**MITCHAM SOCIETY**

## **22/P3620 Mitcham Gasworks Site Western Road Mitcham CR4 3FL**

### **Mitcham Society comments**

**March 2023**

##### Representative view 8 – view from Love Lane looking along Westfield Road

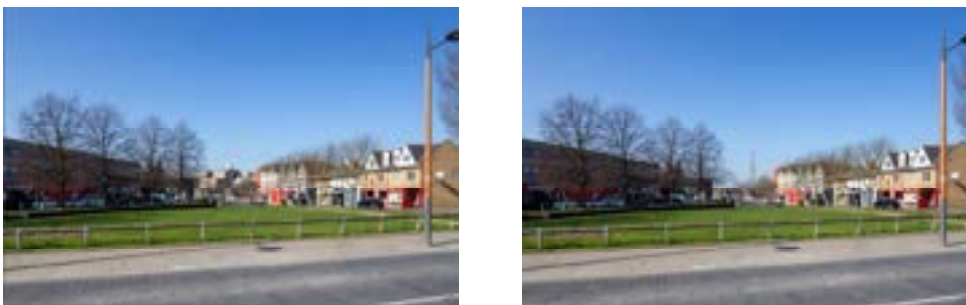
This view is 115 metres from the development site, and even at this distance it is clear that the blocks loom over the cottage style housing in Westfield Road. As you get closer to the site, the looming effect would increase, creating a visual appearance which is depressing and overbearing.
